Re: Florence Copper Project
Draft Underground Injection Control Permit R9UIC-AZ3-FY11-1

**Southwest Value Partners
Comments on
Draft Underground Injection Control Permit R9UIC-
AZ3-FY11-1
Issued to Florence Copper, Inc. for the Florence
Copper Project
Florence, Arizona**

Figure 1. Region 9 Exemption Guidance

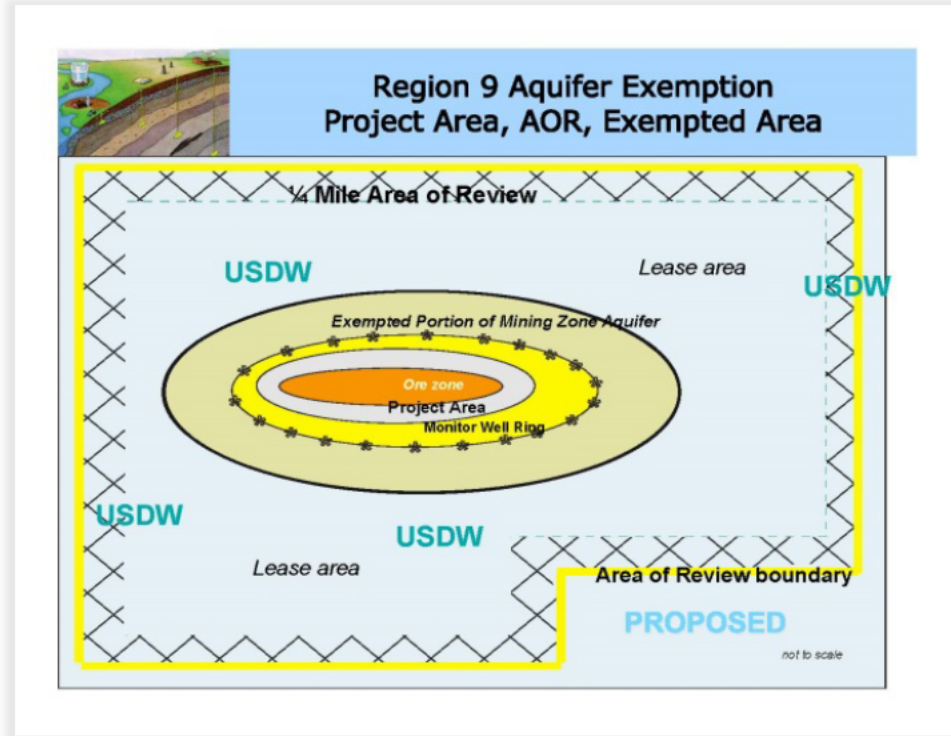
The Statement of Basis for the Draft Permit claims to justify a large exemption area because there are no drinking water wells inside of it today, and existing downgradient drinking water wells are too far from the PTF to be impacted. As a matter of law, this justification is completely wrong; EPA regularly acts to protect aquifers, not just existing wells. We challenge EPA to find any legal authority for its position, or explain why it should ignore its own guidance, illustrated in Figure 1 above.

Figure A-2: Sulfate Values in Observation Wells During BHP Pilot Test³¹

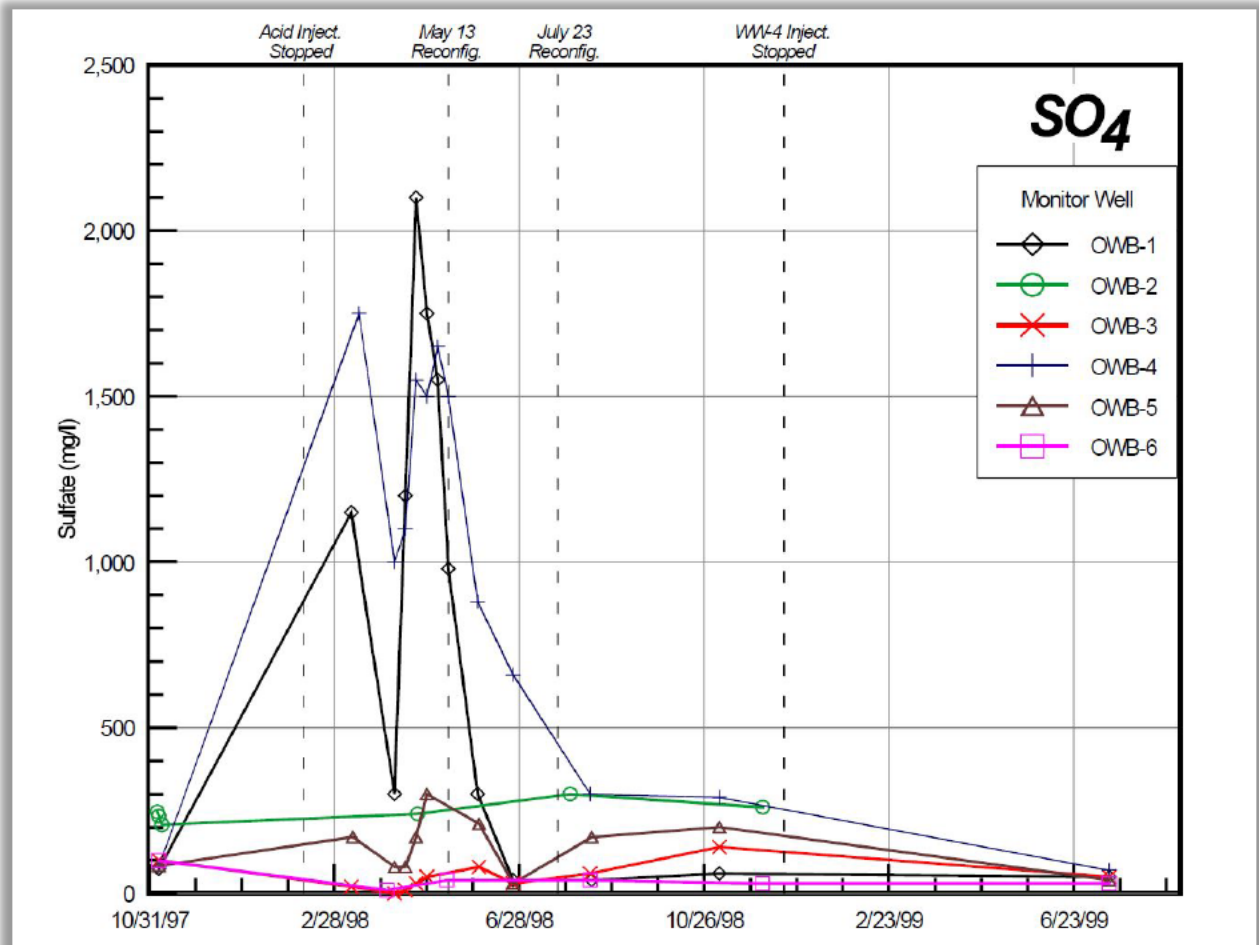
According to Dr. Wilson, the only explanation for these sulfate concentrations is that injected acid solution migrated horizontally to reach the observation wells. And this conclusion is confirmed by the pH data for these same wells, an analysis of which shows results consistent with an escape of acid solution. Review of these results would lead one to believe that injected acid solutions had also migrated beyond the observation wells completely undetected even though all permit conditions were being met.

Figure A-3: Conductivity Difference from Background in mS/m After One Month of Acid Injection During BHP Pilot Test³⁷

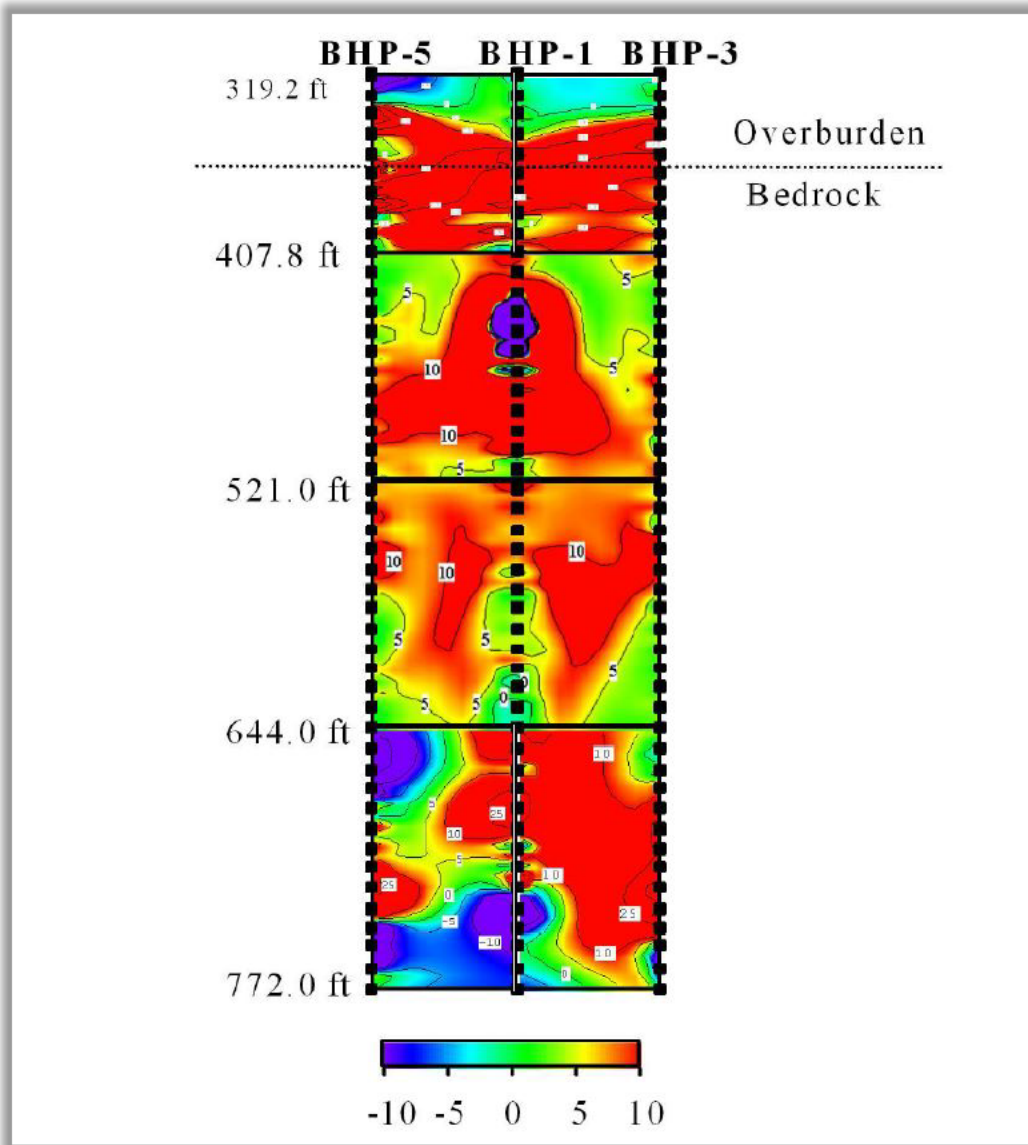
Injected acid also moved vertically into the LBFU during the BHP Pilot Test. BHP installed electrodes along the wellbore of the five injection wells at three-meter intervals. Changes in electrical resistance were measured before and after injection. Because the injected fluid had smaller resistance than formation water, zones with negative changes in resistance represented the flow paths of injected solution.³² These flow paths are depicted in red in Figure A-3 below, with “overburden” representing the LBFU.

These measurements show that BHP’s acid solution migrated vertically 20 feet into the LBFU. This was predicted by BHP³³ and allowed by BHP permit. And this figure is based on acid migration after only 30 days of injection. Region 9 should anticipate greater impacts to the LBFU from the FCI’s more than 400-day PTF. The damage will be even worse from a commercial project where multiple mine blocks will inject millions of gallons of acid over many years.

Figure A-5: Recommended Location of Additional Observation Wells

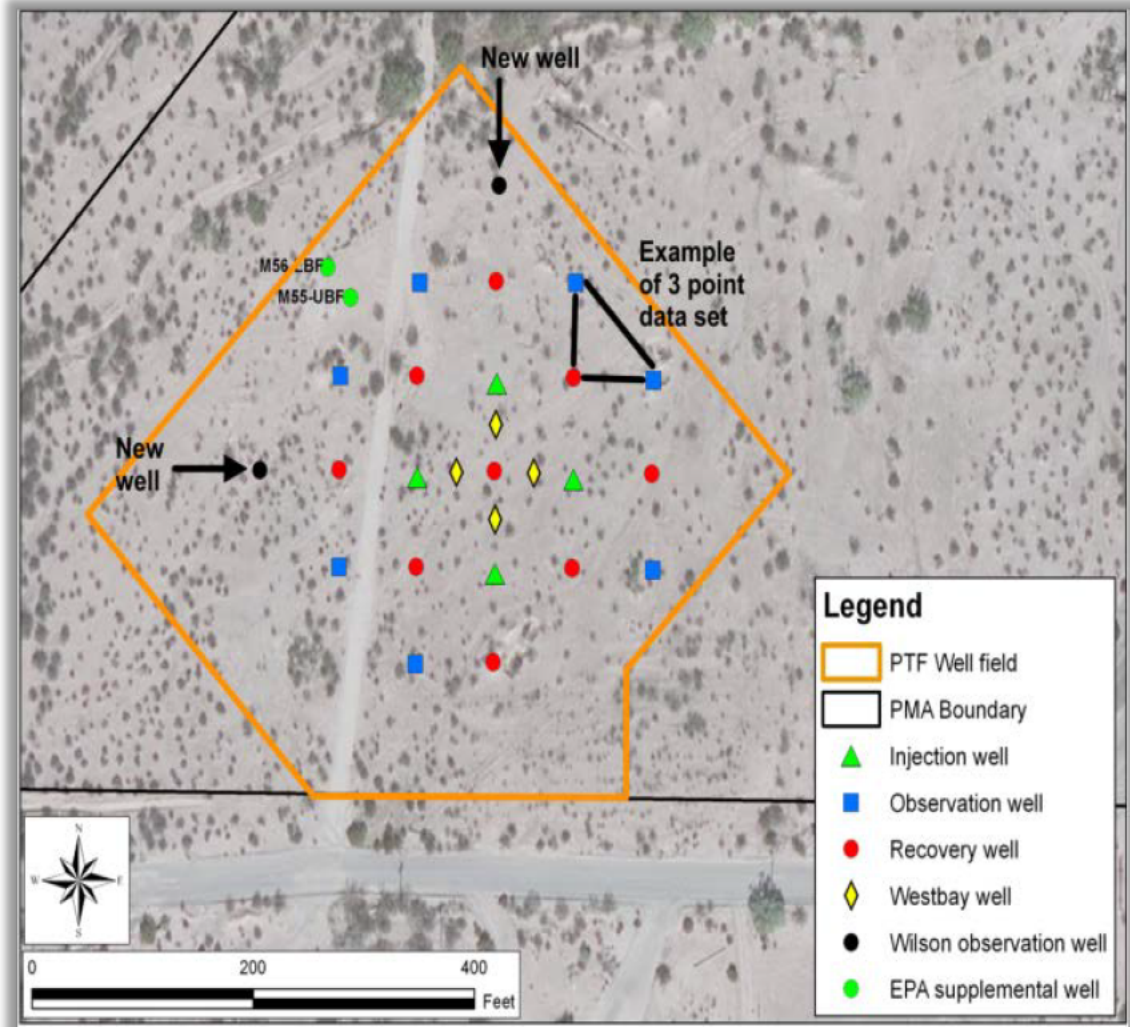
flows in these directions. Consideration of the BHP Pilot Test results mandates that two additional observation wells be installed as depicted by Dr. Wilson in Figure A-5.

Figure C-1. Hydraulic Conductivity Zones Within the Oxide Bedrock in the 5-Spot⁶⁶

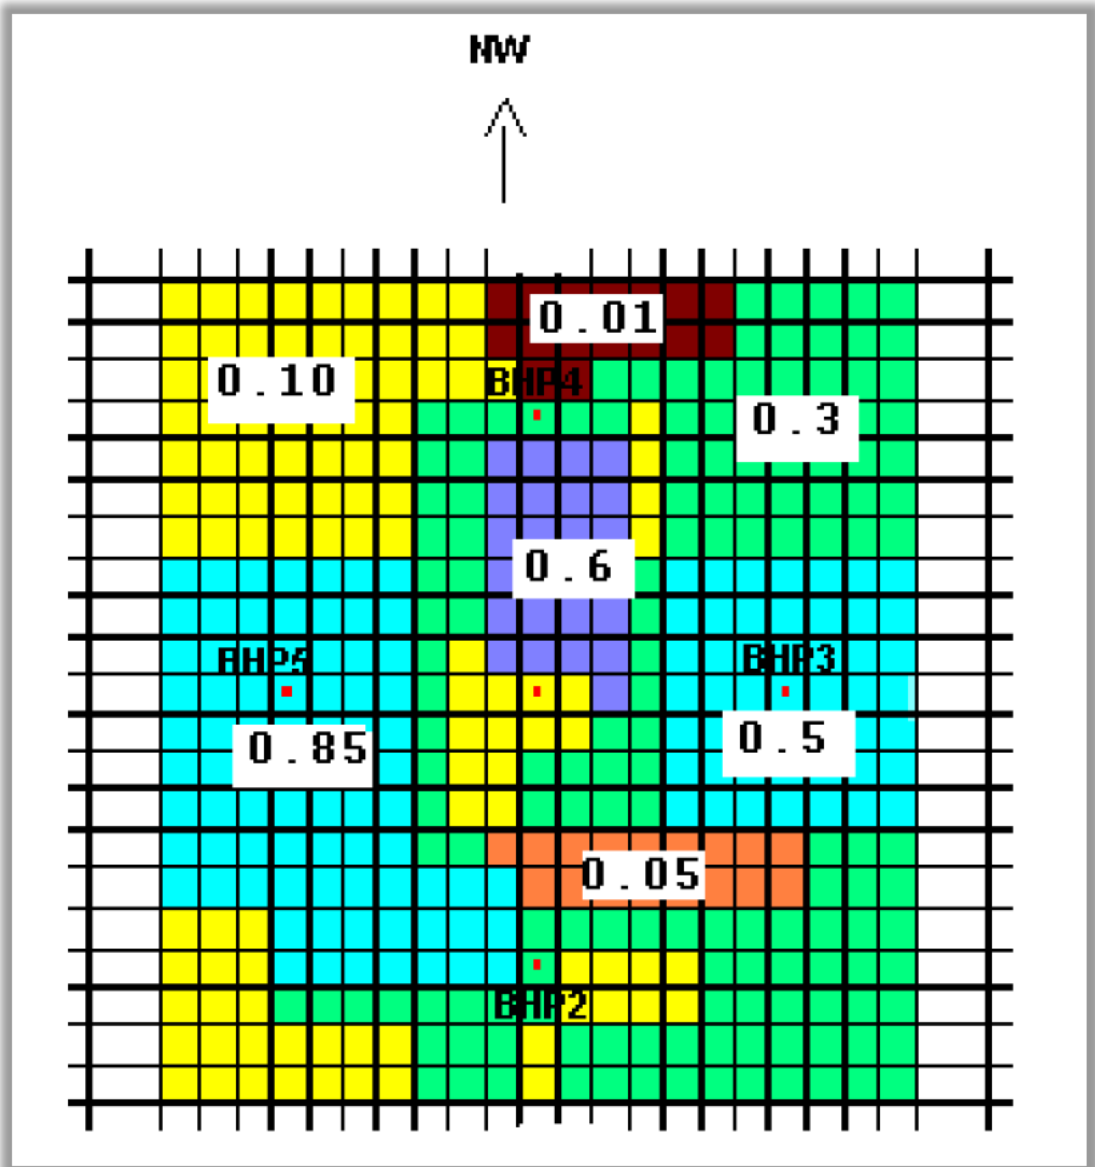
As depicted in Figure C-1, SRK developed a map of hydraulic conductivity values obtained through BHP's aquifer testing program, which was relatively comprehensive. There is no indication at all of the homogeneity that FCI's flow model assumes. The map indicates that some parts of the ore body are 100 times as permeable as others. Values are as high as nearly a foot per day, which would allow good flow and provide a pathway for solute transport. The lowest is one-hundredth foot per day (tenth of an inch per day), which won't allow good flow. If a monitoring well were placed in areas of such low conductivity, they would be useless in detecting an acid escape.

Figure F-1. Region 9 Depiction of Proper Aquifer Exemption Area¹¹⁶

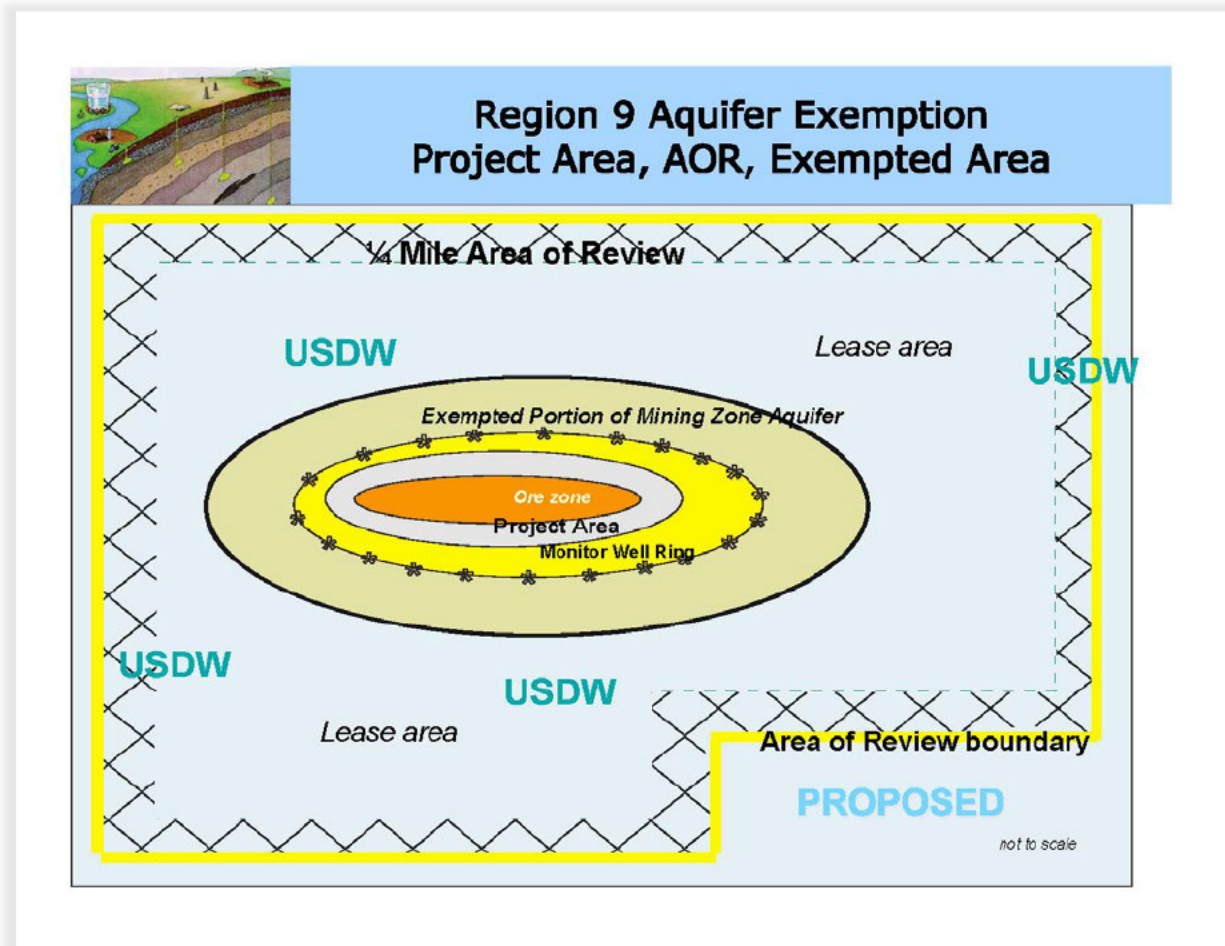
Region 9 cannot subvert proper analysis of the AOR and aquifer exemption criteria to avoid reevaluation of a 20-year old exemption decision. Region 9 has accepted FCI's assertion that contaminant movement is approximately 40 feet per year, such that AOR is a few hundred feet in diameter. Yet the 1997 Aquifer Exemption extends a half mile or more beyond the PTF well field, sacrificing hundreds of lateral acres of the aquifer to a 2-year pilot project with no assurance that commercial mining will or can occur. There is no logic, scientific support, or legal basis for EPA's position.

Figure I-1. BHP Tracer Test Results

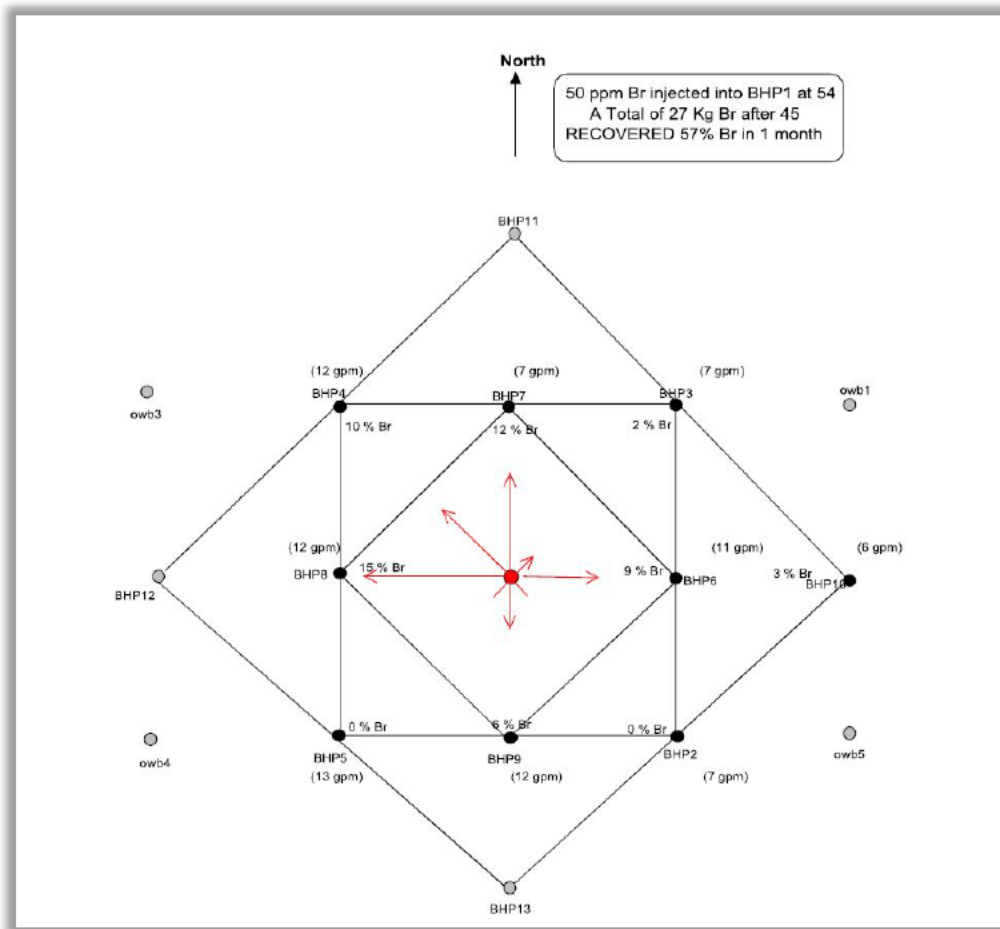
Only after conducting appropriate aquifer and tracer tests can FCI properly design and drill observation and multi-level wells. An example of the importance of this information is shown by BHP's bromide tracer tests, which demonstrated strong groundwater flows due north and due west, in addition to the northwest regional flow.¹⁸⁷ Figure I-1 below depicts the BHP tracer test results, with longer arrows showing stronger groundwater flow. Despite the near certainty of similar flows in this PTF, the draft permit does not require any observation wells in the direction of this strong groundwater flow, to the north and west of the PTF well field.

Figure I-2. BHP Water Balance Data

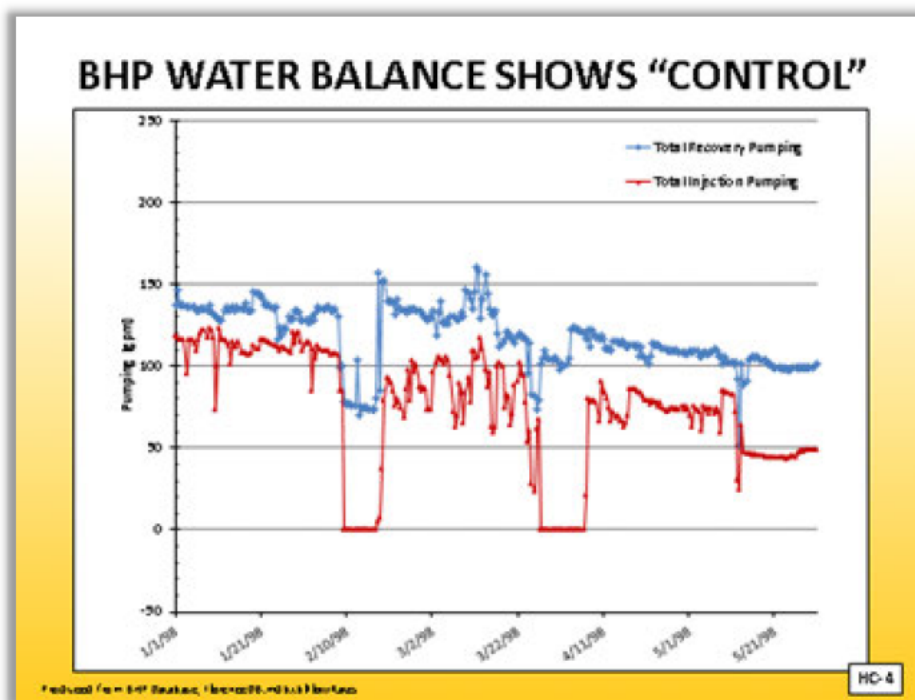
BHP's UIC permit, like this Draft Permit, required that more water be pumped out than was injected.¹⁹³ BHP appears to have fully complied with this requirement. In response to the subpoena, FCI produced a database from the BHP Pilot Test that included injection and recovery volumes during the test.¹⁹⁴ As seen in Figure I-2 below, Dr. Wilson plotted the respective volumes on a graph to visually depict BHP's compliance with the requirement to recover more fluid than was injected. In the graph, the red line depicts injected acid and the blue line shows fluid recovered. Recovery is always higher than injection, indicating that BHP complied with the water balance permit condition. Although in theory this requirement was intended to ensure that no acid escaped, we know that acid solutions did migrate beyond the recovery wells and out of the Oxide Zone. Thus, the requirement that FCI recover more fluids than it injects does nothing to prove that FCI has prevented the migration of acid mining solutions.

Figure I-3. Calculation of Sulfate Balance

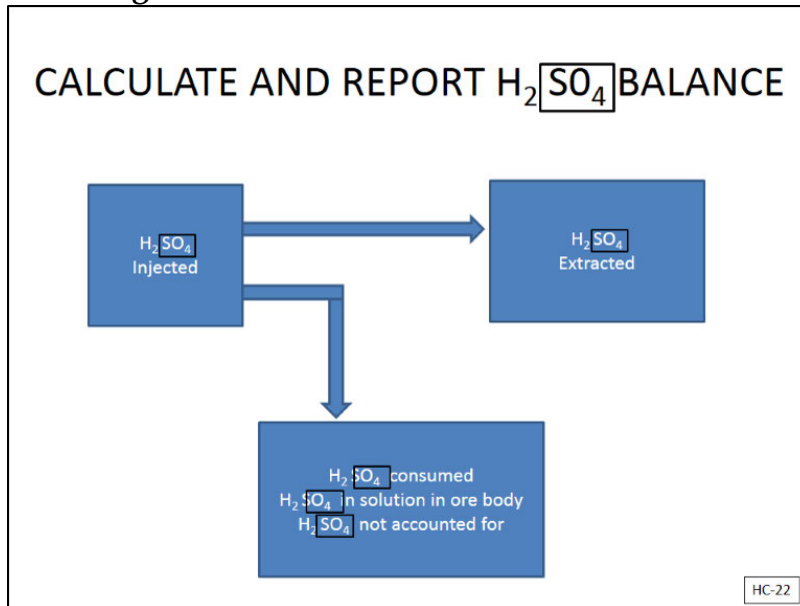
Instead, a meaningful permit must require FCI to calculate and report an acid balance or a sulfate balance.¹⁹⁹ As depicted in Figure I-3, all sulfuric acid injected in the aquifer must end up in one of four places: (1) extracted fluids; (2) consumed in chemical reactions in the oxide zone; (3) solution that remains in the ore body; or (4) fluid that has escaped the well field. By requiring FCI to calculate and report an acid or sulfate balance, EPA can determine whether FCI has properly accounted for all of the acid that it injected into the aquifer. A failure by FCI to account for all of the acid that it injected shows that FCI has not maintained hydraulic control.

Figure I-4. BHP Gradient Data

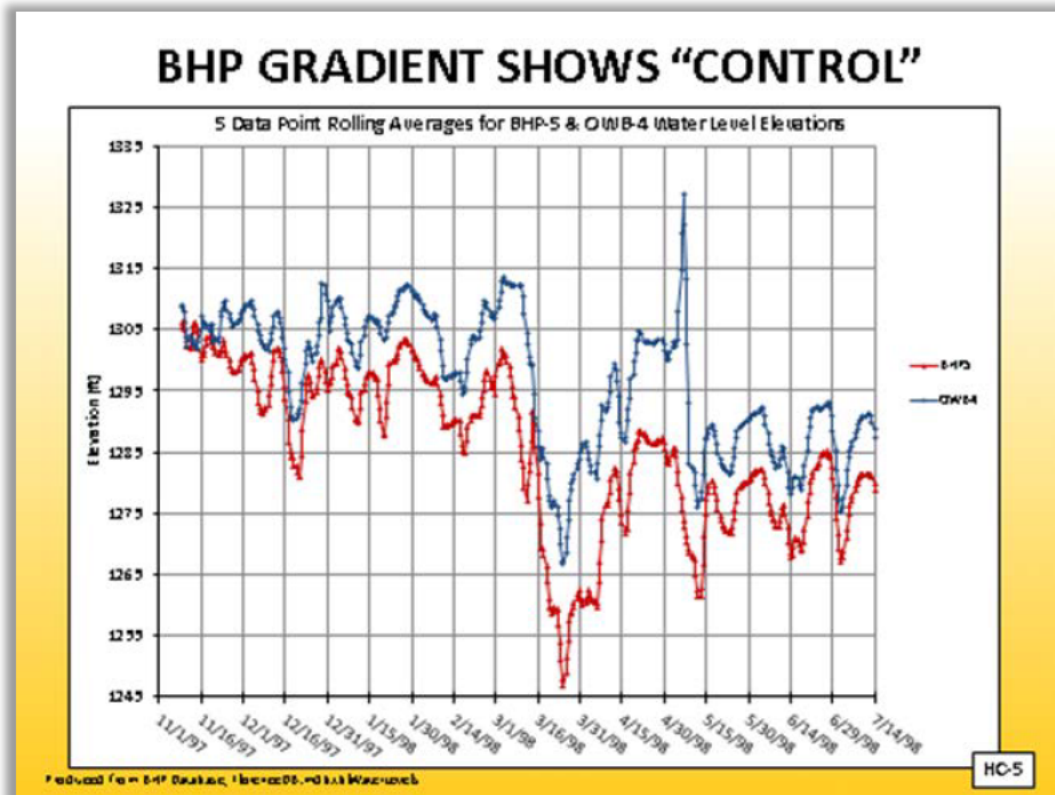
Based on BHP Pilot Test database produced by FCI, Dr. Wilson visually depicted the gradient data for BHP-9 and OWB-4, the recovery-observation well pair in the southwest corner of the BHP Pilot Test well field. In Figure I-4 below, the blue line depicts the outside, observation well water level and the red line displays the inside recovery well water level. The observation well's water level is higher than the recovery well's in all cases, indicating there was an inward hydraulic gradient. But as has already been noted, OWB-4 experienced numerous high sulfate concentrations in March and April 1998, indicating horizontal acid escape toward that observation well.

Thus, BHP complied with the water gradient permit condition in its permit during the same period when a known acid escape occurred. This demonstrates that a measured inward gradient is not enough to demonstrate hydraulic control.
